September 30, 2024

**THE UNIVERSITY OF NEW ORLEANS
SCIENCE LAB UPGRADES PHASE III
H/S PROJECT NO. 23044**

**HOLLY & SMITH ARCHITECTS, APAC
2302 MAGAZINE STREET
NEW ORLEANS, LOUISIANA 70130**

This addendum forms a part of the Contract Documents and modifies the original specifications and drawings issued for bidding to the extent noted hereinafter.

CROSS SECTION EAST WING AT COURT
SCALE 1/4" = 1'-0"

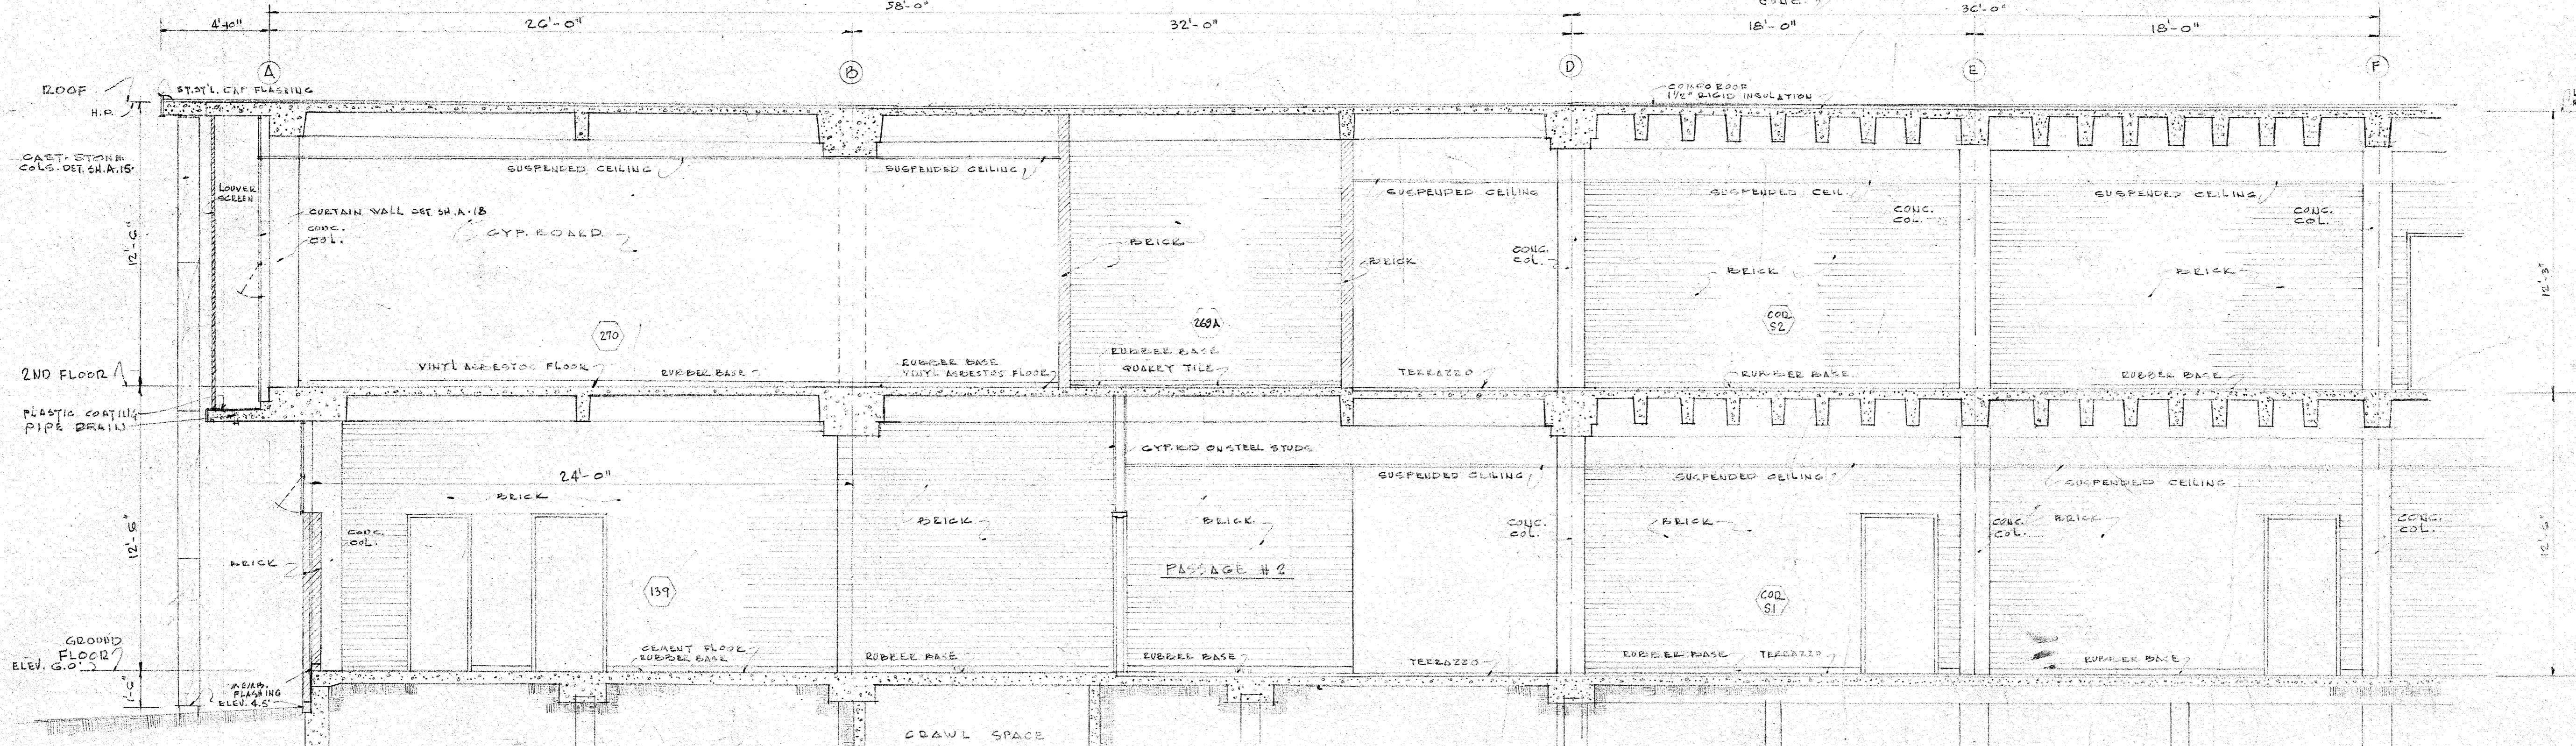
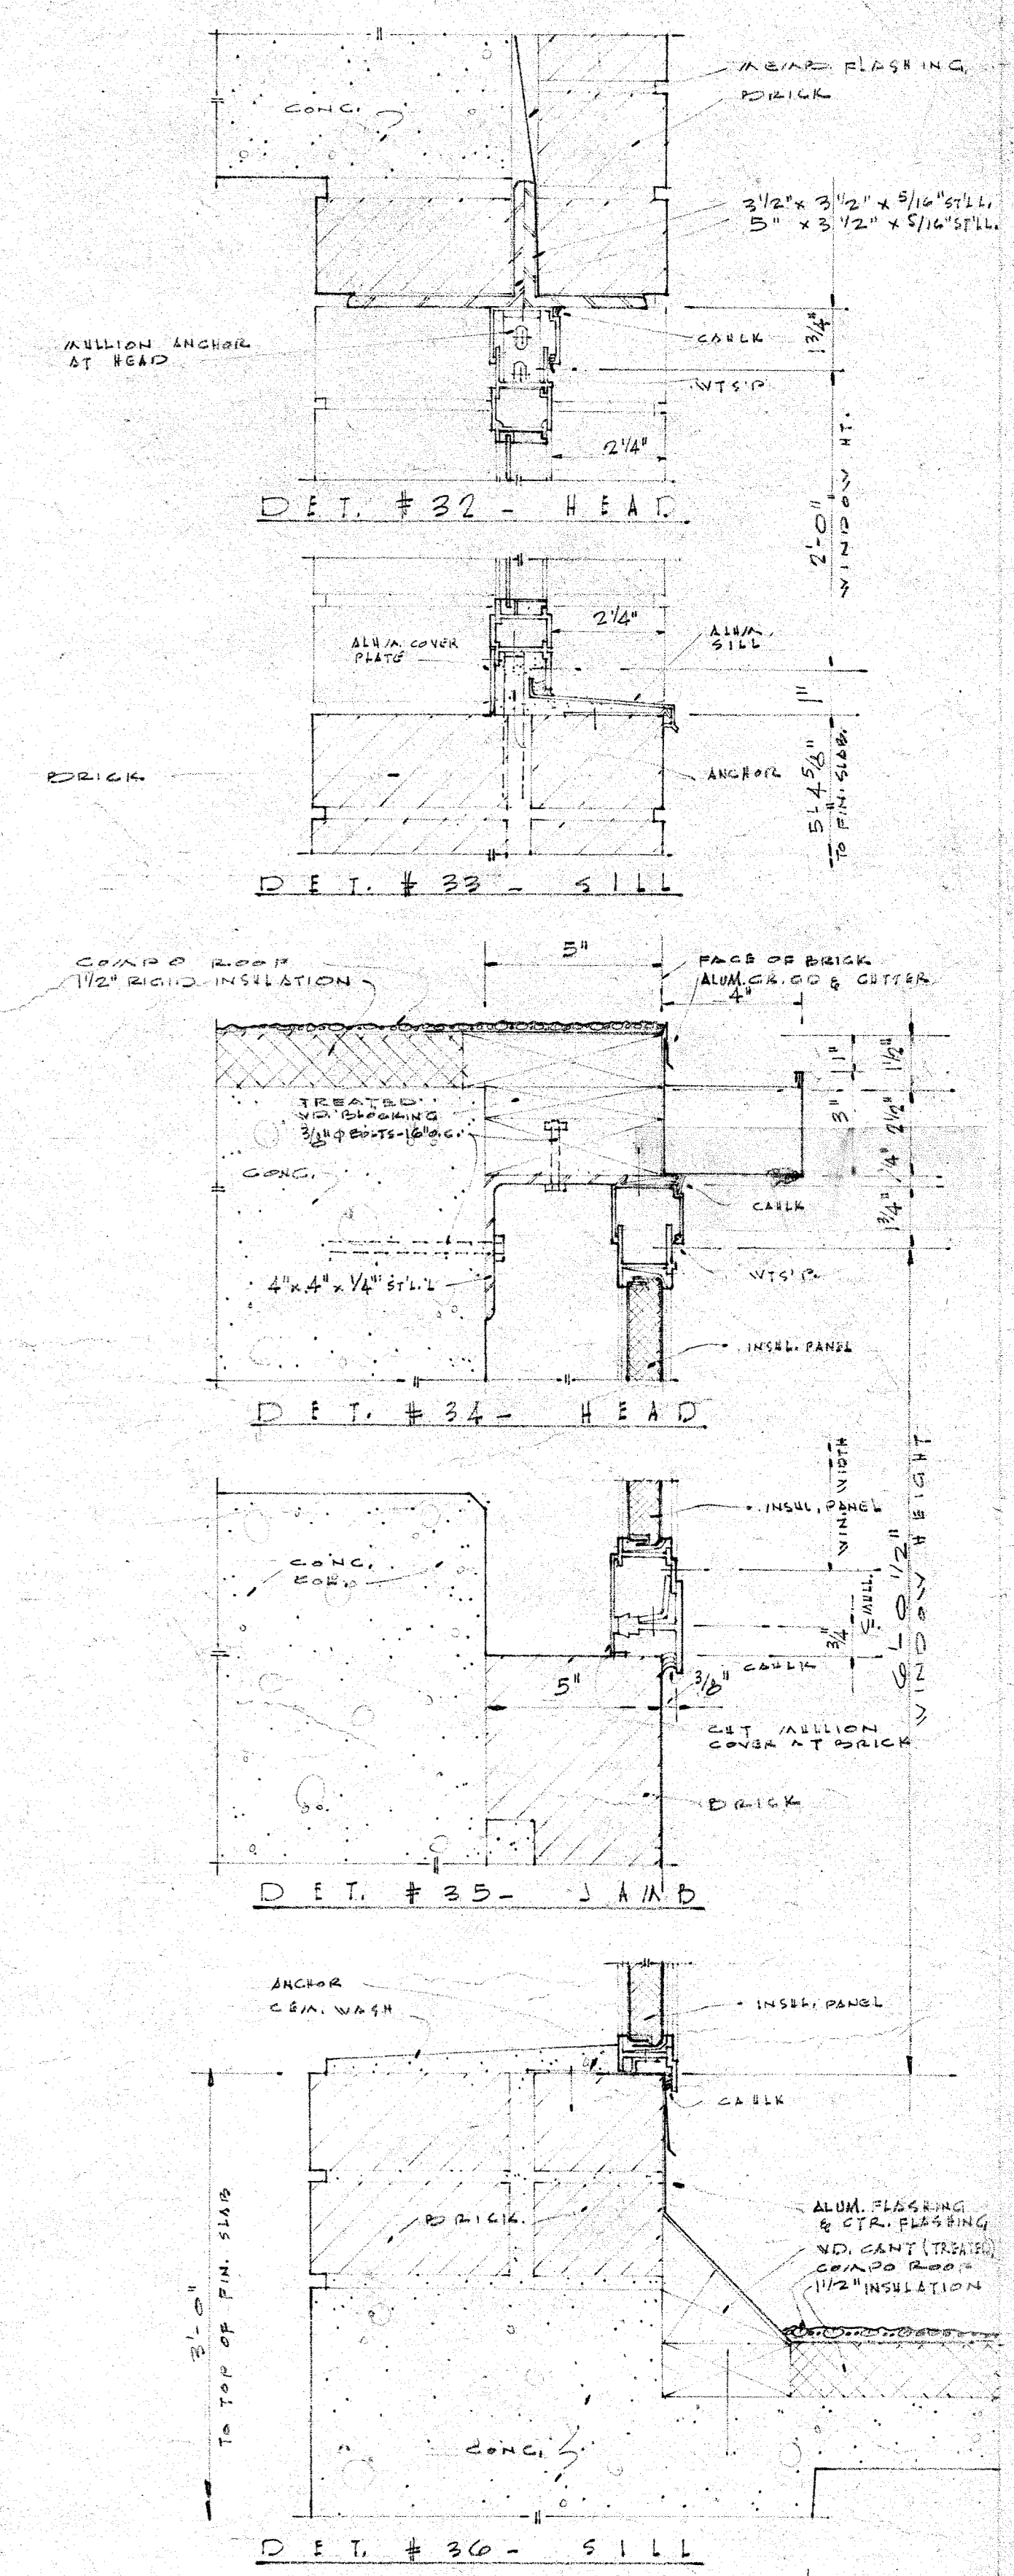
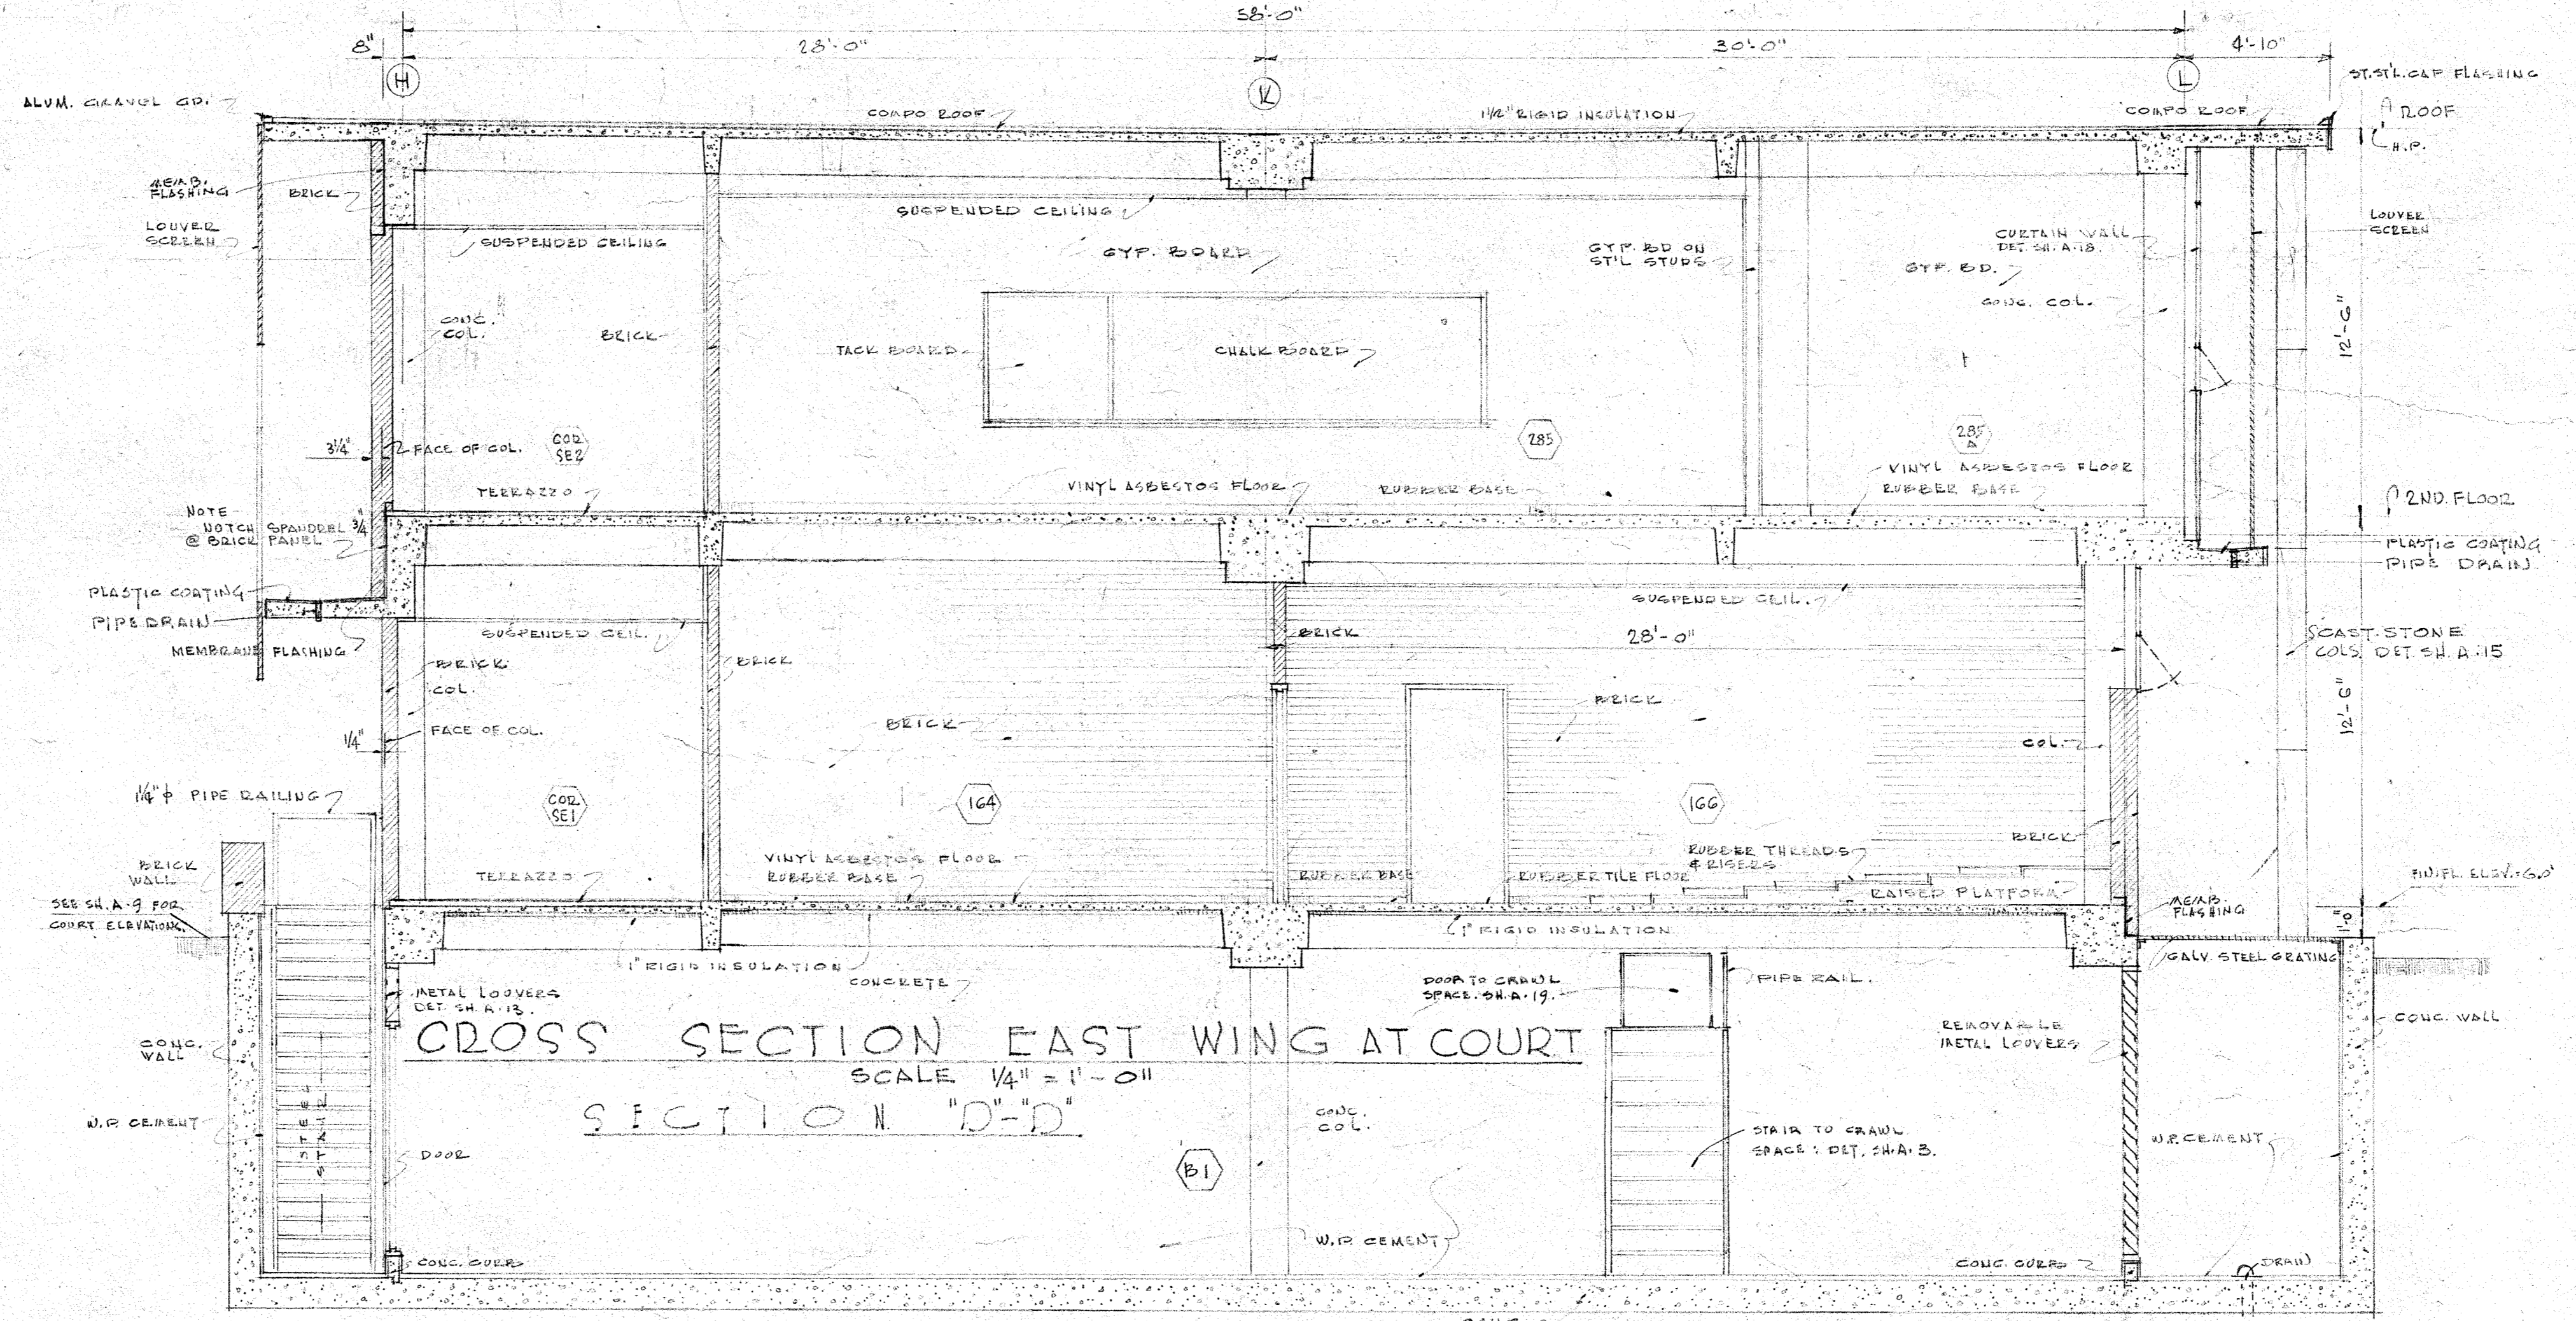
- 2.1 A copy of the original drawings identifying access to the crawl space, crawl space plumbing plan, an existing section of the crawl space, and images of the crawl space are included in this addendum for reference only. Contractor must verify existing conditions on site.
